Field Remedy: 2676

Subject: Instrument Panel Fuse Box - IEC Bus Bar Incorrect Numbering

Astra-J 2010, Insignia 2010

Correct numbering of the IEC Bus bar (Picture I)

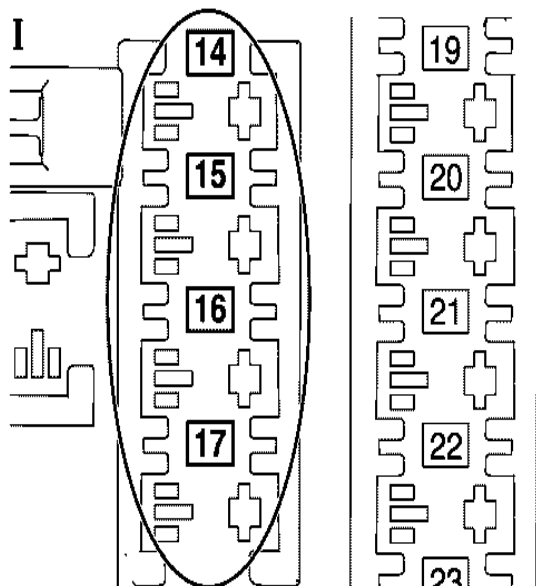
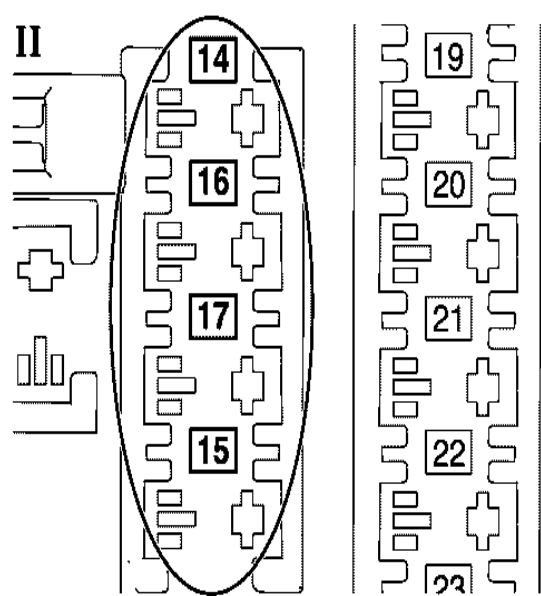
Some vehicles have been equipped with an IEC Bus bar with an incorrect numbering.

Incorrect numbering of the IEC Bus bar (Picture II)

Note: Only the numbering on the IEC Bus bar is wrong!
The electrical connector configuration is OK.

14 = Diagnostic connector
16 = Airbag
17 = Central Locking System
15 = HVAC

14 = Diagnostic connector
15 = Airbag
16 = Central Locking System
17 = HVAC
